618 JOHN STREET

SDCI PROJECT 3038245-LU

DESIGN REVIEW BOARD | RECOMMENDATION MEETING SEPTEMBER 07, 2022

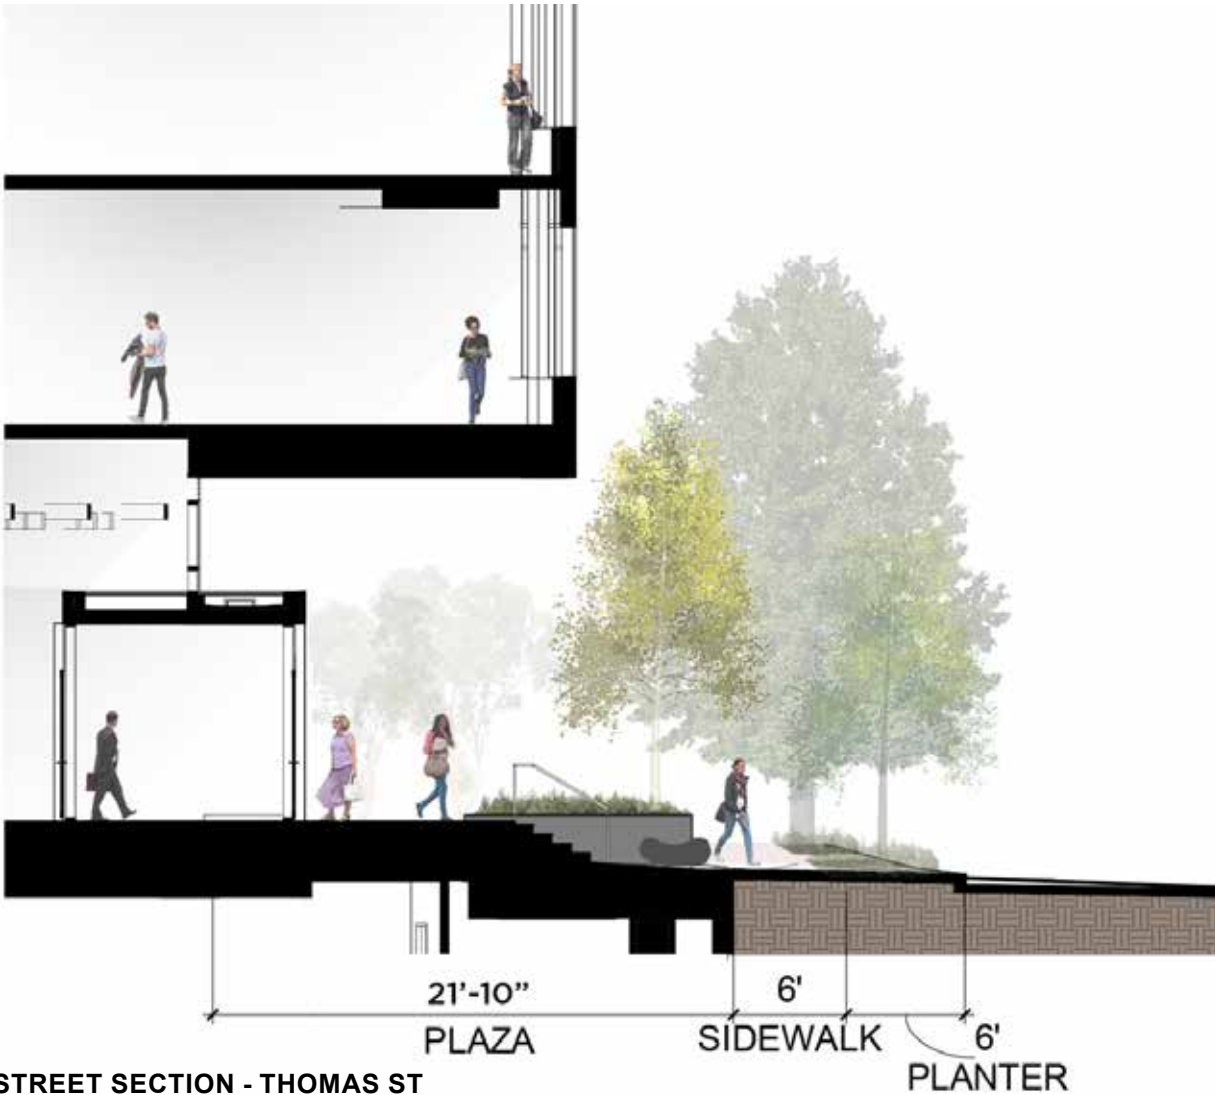
2b - Provide street-level sections, planting diagrams, signage, lighting clarification at the next meeting, considering how pedestrian scale can be enhanced. (uptown PL1 Connectivity, uptown PL3 Street-Level Interaction, PL4-A Entry Locations and Relationships, DC3 Open Space Concept)

The proposed design has considered pedestrian scale along all three street frontages. Enhancements include rich and textured materials at the ground floor, raised planters, integrated bench seating, stepping the base of the building with the grade and clearly marked entrances. The design has provided further clarity on the planting, signage and lighting in the respective sections of the design review book.

SOUTH PLAZA PLAN

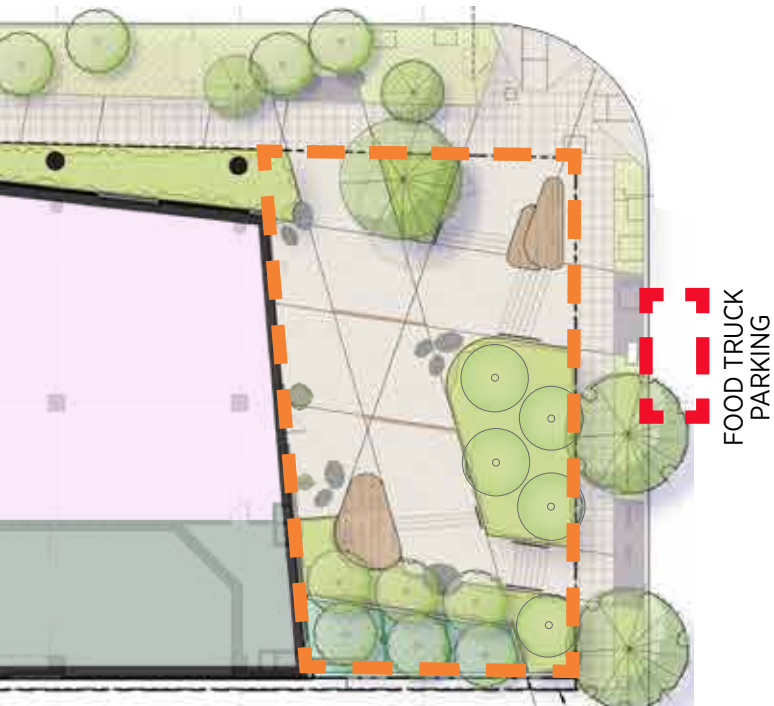
2c - The Board was intrigued by the potential for spill out space on the south plaza but noted there were no openings proposed currently. At the next meeting further clarify how this space will be activated and what cues will signal this space as public. (Uptown PL1 Connectivity, Uptown PL3 Street-Level Interaction, PL4-A Entry Locations and Relationships, DC3 Open Space Concept)

The proposed design has a large sliding glass door at the ground level that opens out to the south plaza to invite public/private interaction. The plaza is designed to be welcoming and porous to pedestrians with several areas of respite and platforms for larger gatherings. The plaza will be well lit at night for safety and comfort without impacting the residential building across John St.

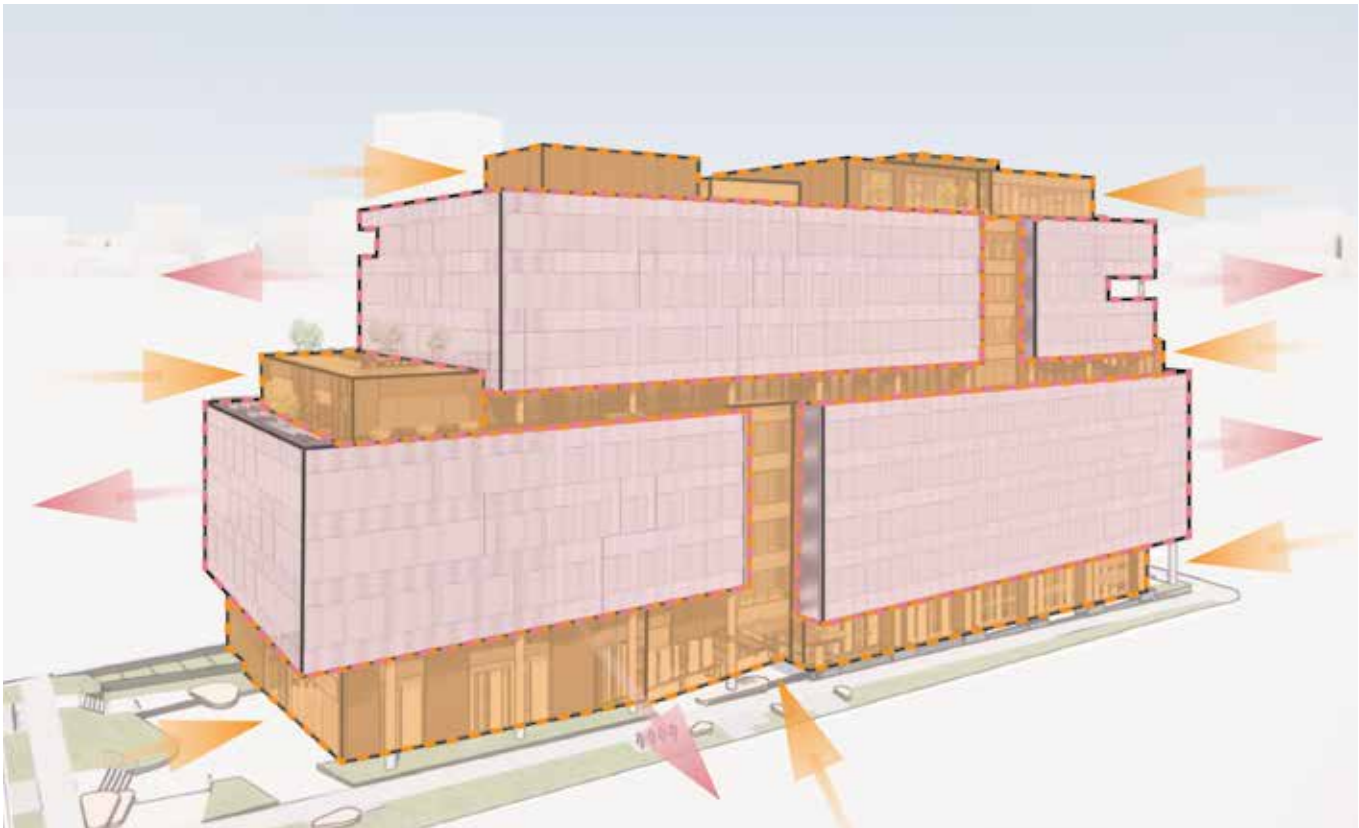
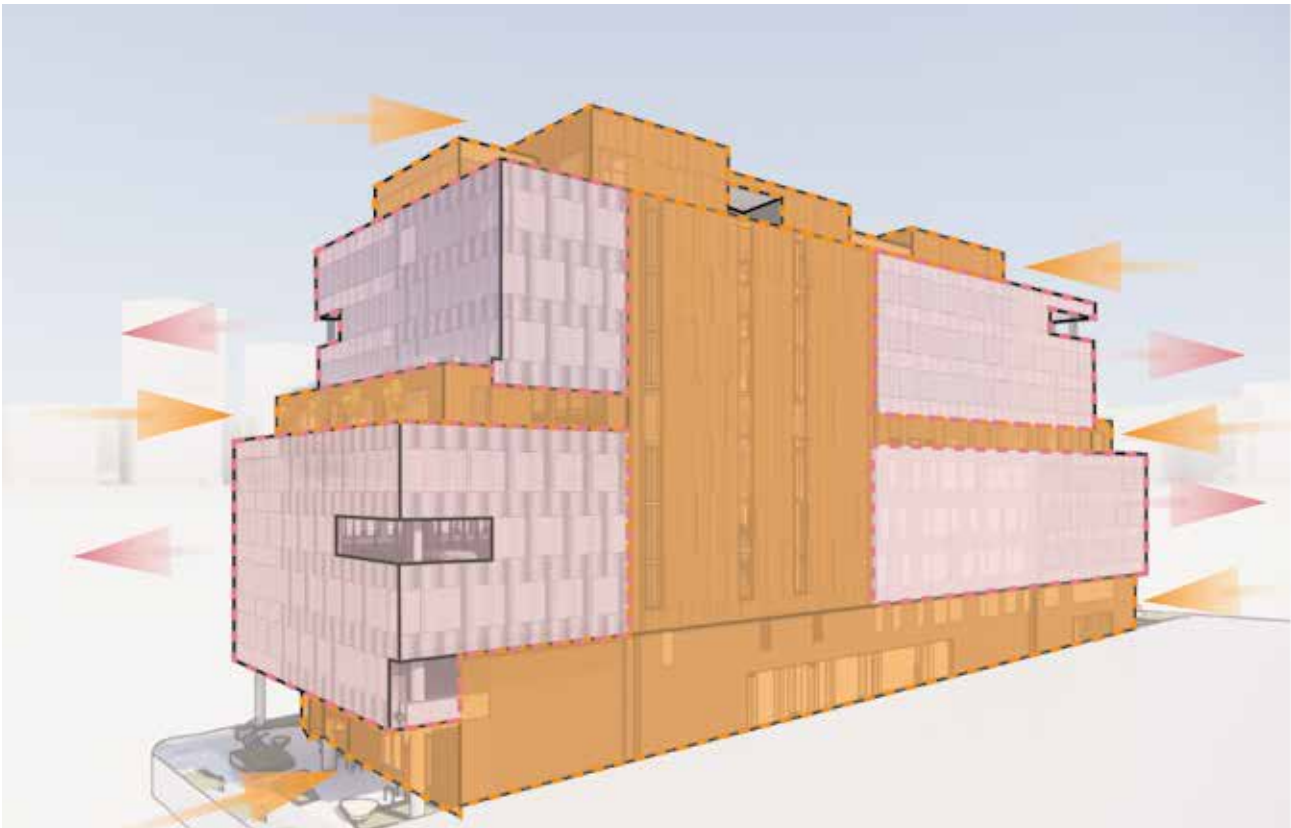
3a - Moving forward, the Board noted that material will be critical in further breaking down and strengthening the architectural concept. In addition, the Board noted they would like to see material carried around the building to further support the 4-sided design approach. (uptown DC4 Exterior Elements and Finishes)

The proposed design uses materials to strengthen the architectural concept. Each material is represented on all four sides of the building to enhance the four sided design approach.

WEST FACADE

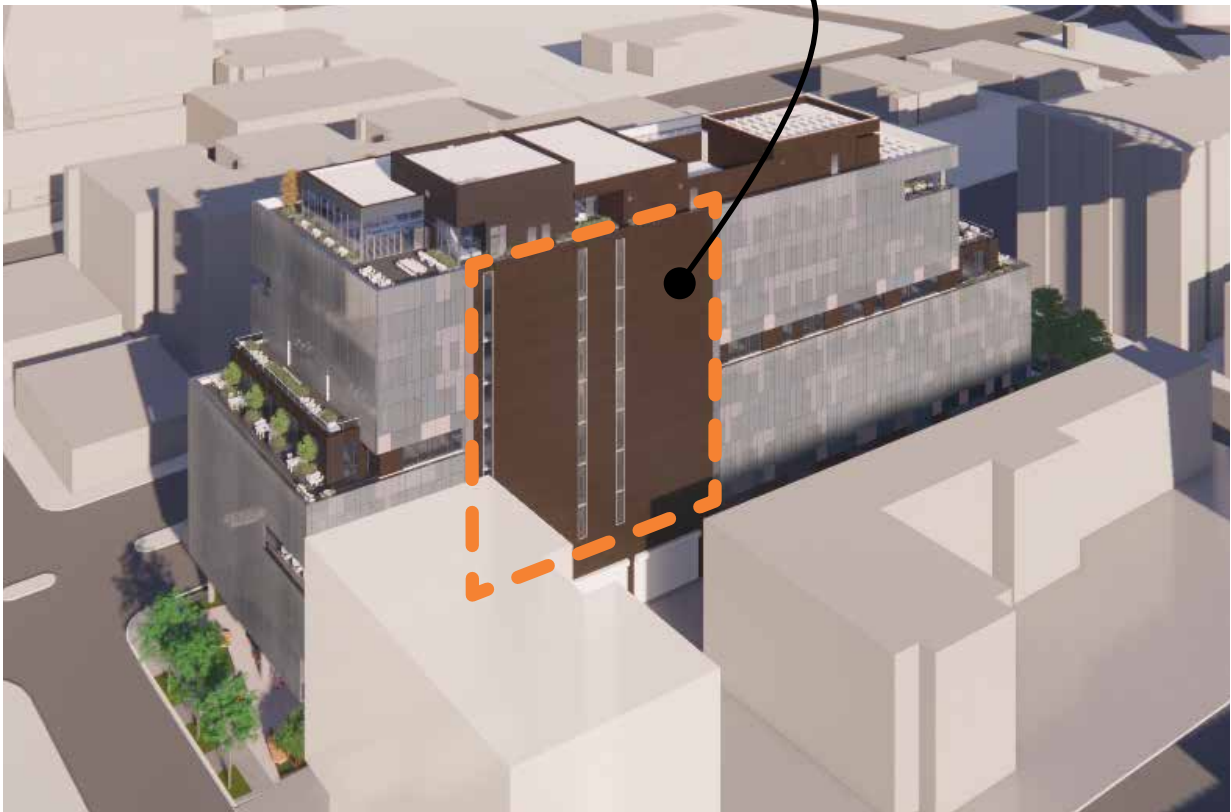
3b - In agreement with comments by the public, the Board directed the applicant to consider how art can be integrated into the project site. (uptown CS3-1-b. Visual Art, uptown DC4 Exterior Elements and Finishes)

The project is proposing a location for a potential mural on the Alley wall facing towards the Space Needle. The project team is planning to reach out to local artists to provide a design using the highlighted area as a potential canvas for a mural.
